| REV | DATE     | DESCRIPTION        | DN | AP |
|-----|----------|--------------------|----|----|
| 8   | 12/11/25 | DA Response        | NC | MF |

SHEET TITLE  
BASEMENT 1 PLAN

PROJECT  
ORAN PARK  
COMMERCIAL 5  
PROJECT  
NO 12

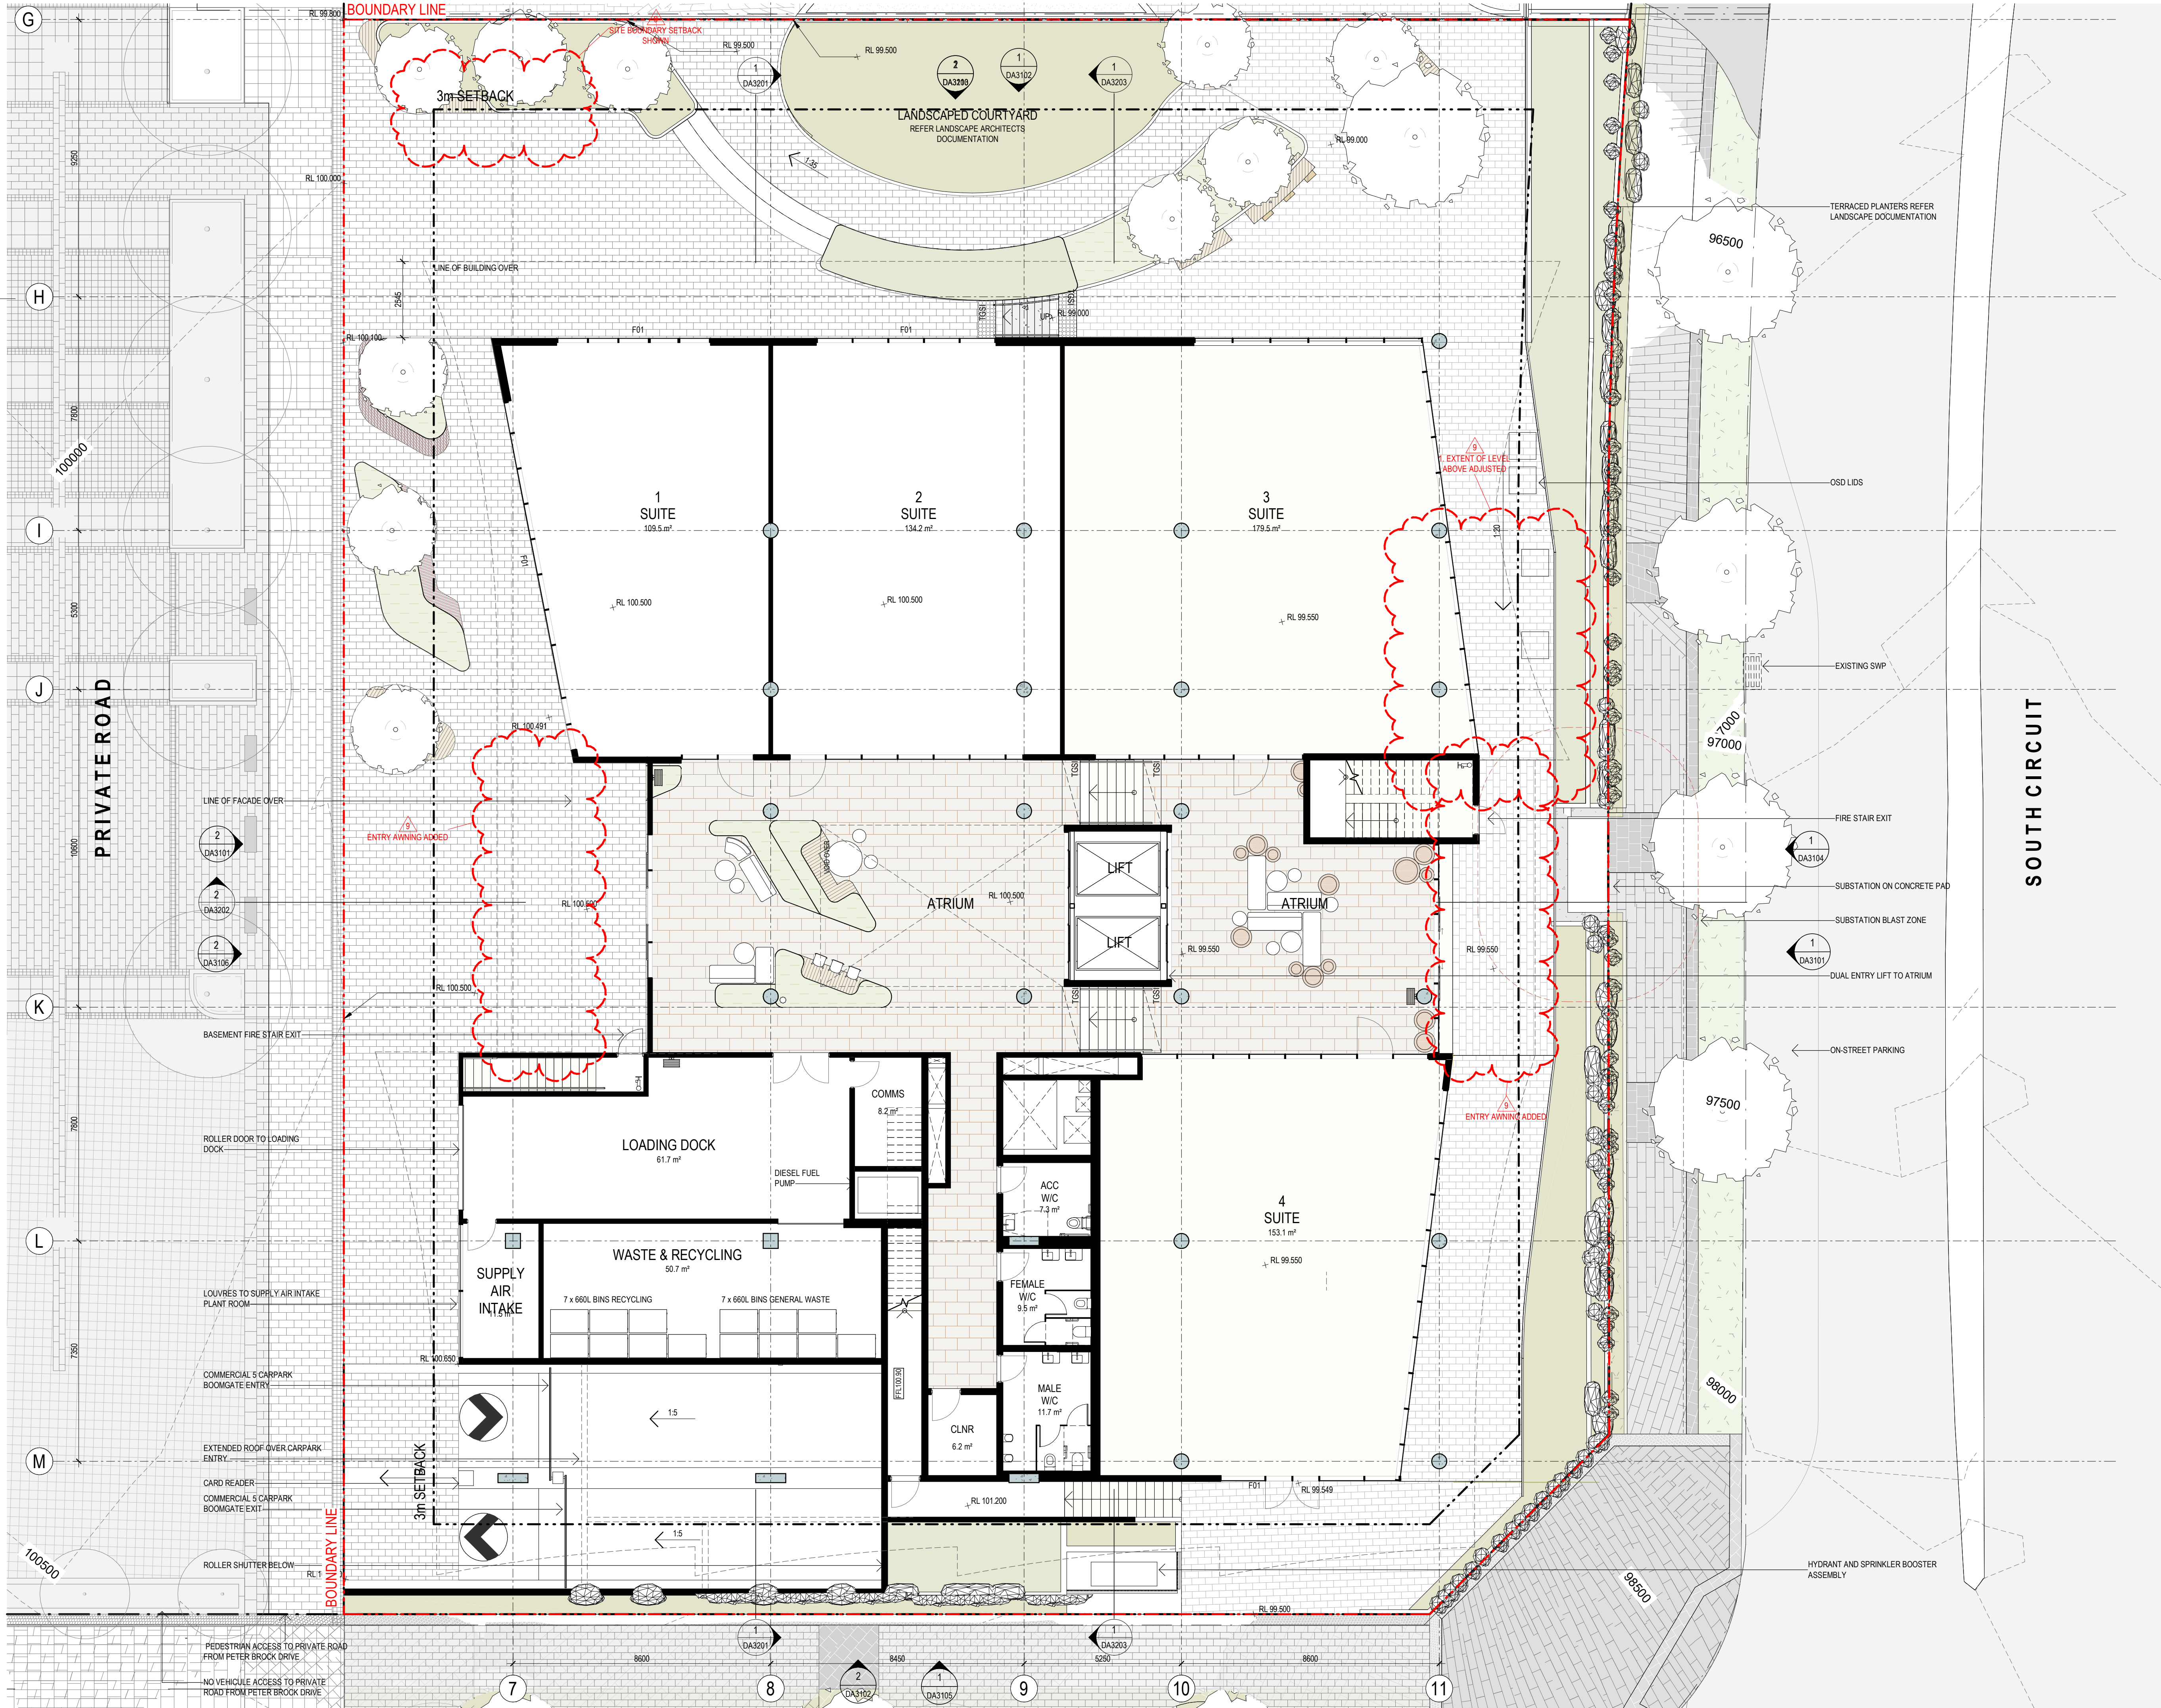
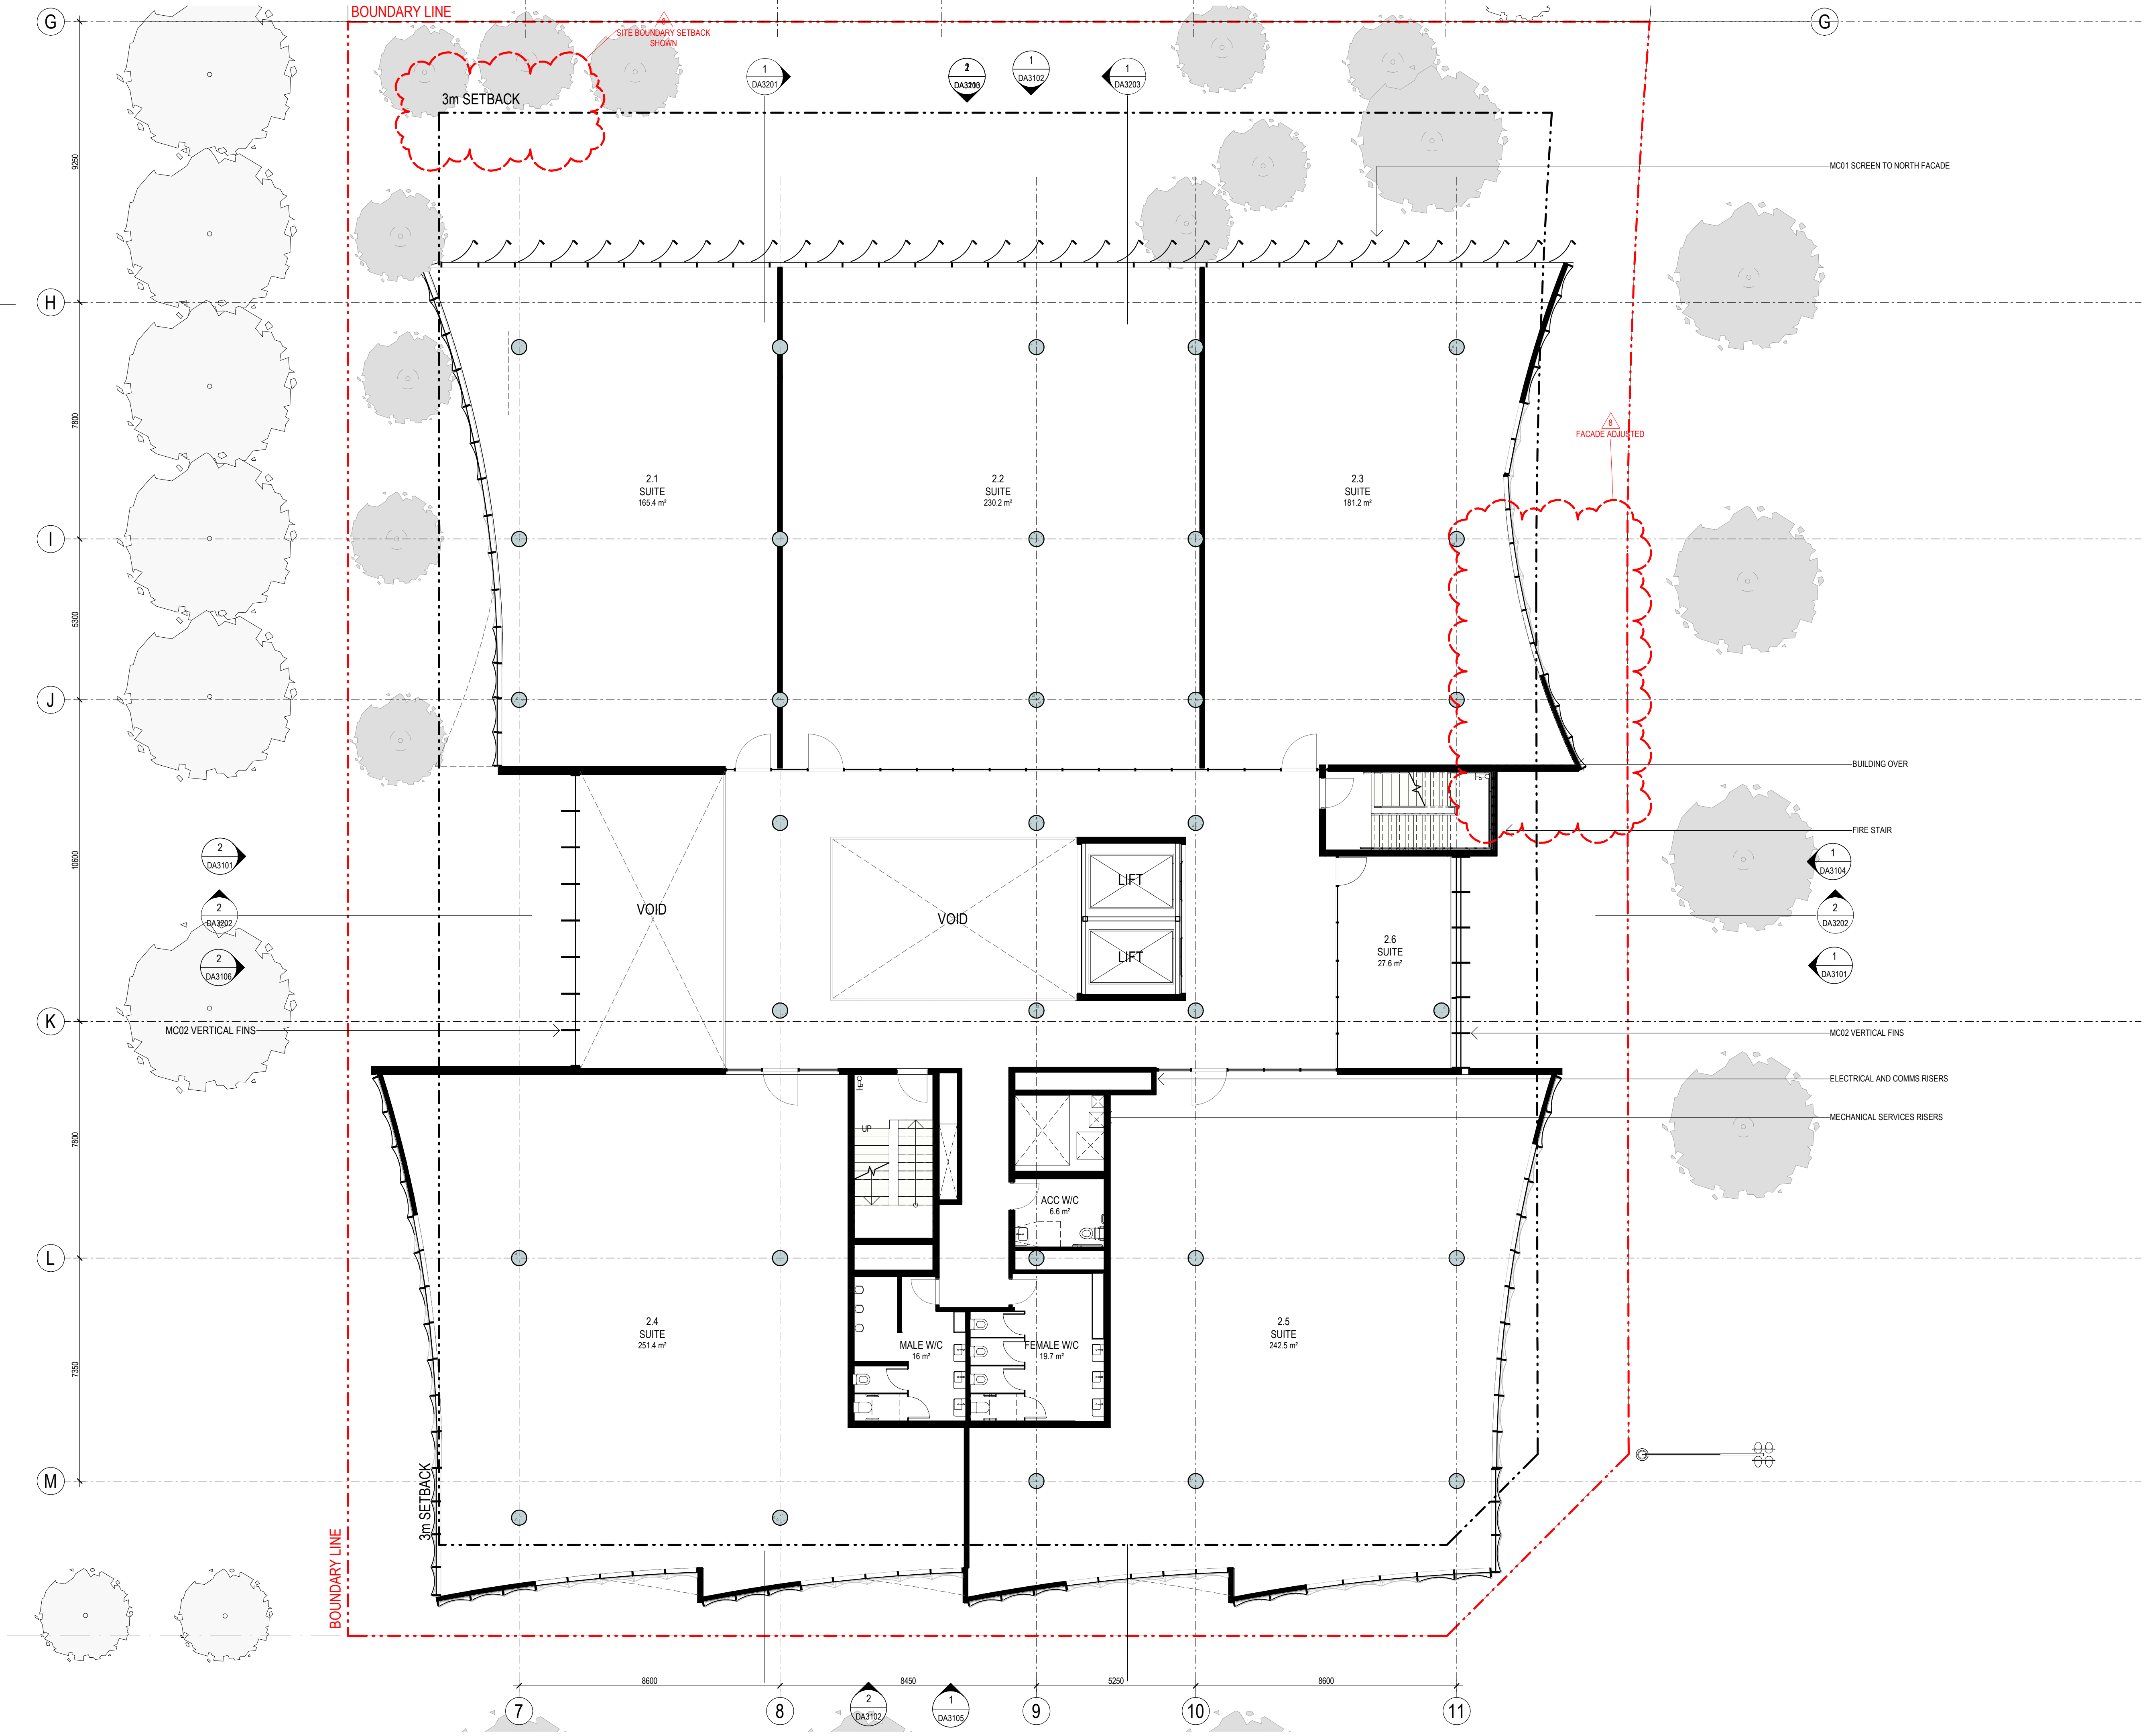
GENERAL NOTE:  
DIMENSIONS ADDED TO CAR PARK AREAS  
THROUGHOUT BASEMENT LEVELS

7  
ADDITIONAL DIMENSIONS  
ADDED

ADDITIONAL DIMENSIONS ADDED

GENERAL NOTE:  
DIMENSIONS ADDED TO CAR PARK AREAS  
THROUGHOUT BASEMENT LEVELS

NEW SHEET ADDED TO SHOW  
DETAILED CARPARKING SPACES  
UNDERNEATH RESI 4.

1  
CAR SPACE NUMBERS  
UPDATED AND ADDITIONAL  
VISITOR SPOT ADDED AND  
EV SPACES ADDED
